PILLAR CONSULTANTS, INC.
Consulting Engineers, Planners & Surveyors

October 16, 2023

Re: Sierra Ranches Lake/Wetland Preserve Analysis
Job Number: 23078
Cross-sections and Earthwork Analysis

Shoreline Cross-Section (showing Open Water Channel/Buffer, Hydric Berm and 10' depth)
(Elevations shown are in NGVD = NAVD+1.6')

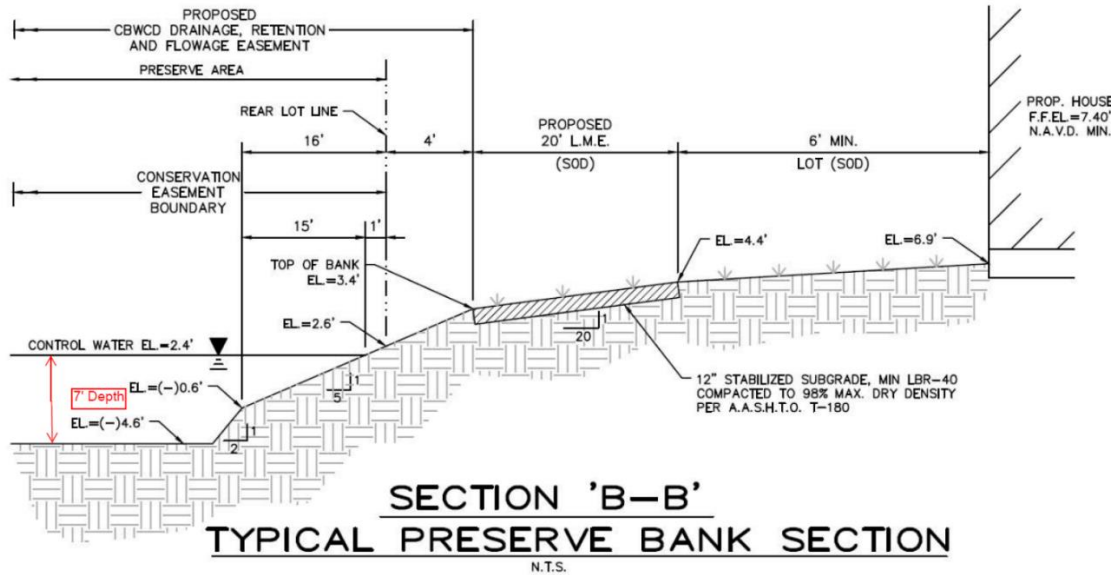
The design of the project went through different iterations under different owners and wetland consultants. There are many different governmental and regulatory agencies that govern projects of this size and when existing wetlands are present. The South Florida Water Management District (SFWMD) is one such entity that governs over wetland mitigative efforts and surface water management concerns (ie flood control) and issues permits associated with proposed development. Between 2003 and 2006, SFWMD had received applications for development of a 62 unit, single family home development on this same property that included onsite wetland mitigation of 13.81 Acres (within a preserve): Application #031215-9. The wetland preserve design provided similar features to the current design, including open water channels (called an open-water buffer), hydric Islands, marsh area and transitional buffers; and an additional feature known as a hydric berm, not included in the current design. It was noted that the depth of the open-water buffer was prescribed at 10 feet deep and included a hydric berm to confine the wetland well beyond the limits of the shoreline (approximately 75' of open water channel-buffer). Please see below for the proposed cross-section from the previous set of plans:

The new design incorporated a larger wetland preserve, consolidated on the eastern side of the property (see above: Current Wetland Preserve Plan View). This new design, although an overall larger area, reduced the width of the open water channel/buffer (from 75' to 35'), provided conflicting details of the depth of the open water channel (10' and a reduced 7' depth) and removed the hydric berm altogether. See below for the conflicting cross-sections utilized in the current design permitted plans:

Current Cross-Section from Paving Grading and Drainage Plans (showing 7' Channel)
(Elevations shown are in NAVD = NGVD-1.6')

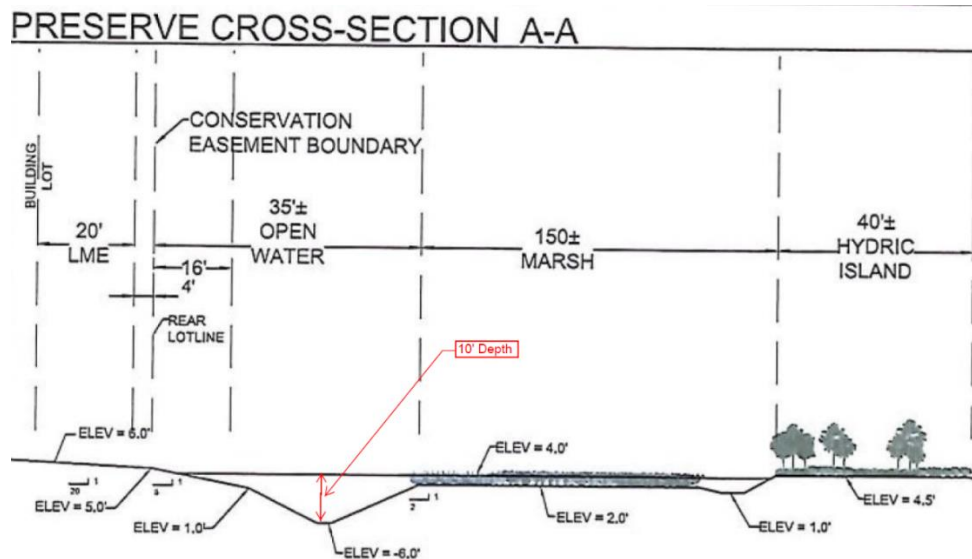
Both the cross-sections above are supposed to represent the shoreline adjacent to the homes adjacent to the preserve. They are also from the same permitted set of plans with SFWMD and were utilized in the construction of the development, however, they differ in the proposed depth (10' vs 7') required in the Open-Water Channel/Buffer.

Based on the findings of the recently acquired cross-sections and the assumed sloughing of the open water channel due to not being deep enough, nor the inclusion of a hydric berm to hold back the wetland marsh soils in place, we believe that the channel should be reshaped to the deeper depth as prescribed in the approved plans (10'), widened to accommodate the new depth with required sloping, mixing of rock into the slopes to achieve a LBR40 (lime rock bearing

ratio) and inclusion of a hydric berm to assist in holding back assumed soughing that has taken place.

Aerial View of Wetland Preserve (taken 2022)

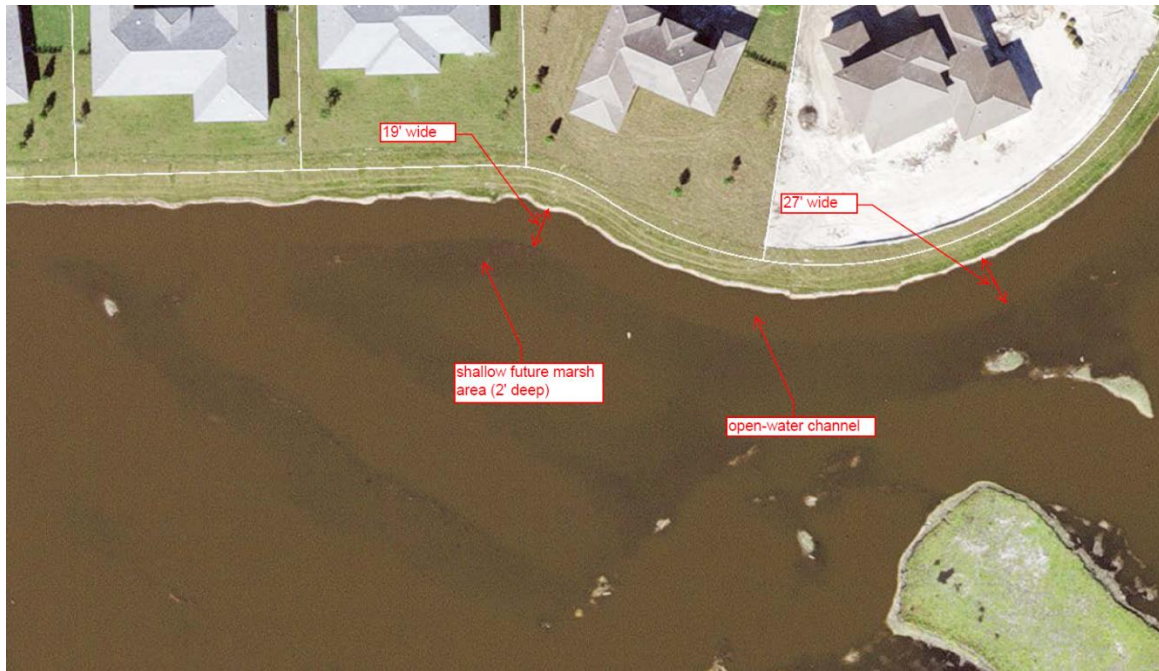
website), there is a distinction between the proposed future wetland marsh areas (not yet planted at the time the aerial was taken in 2022) and the area near the shore line where the open-water channels were proposed. The prescribed width of the open-water channels per the plans was 35' however, as measured, the open water channel in certain locations is less than 20' wide.
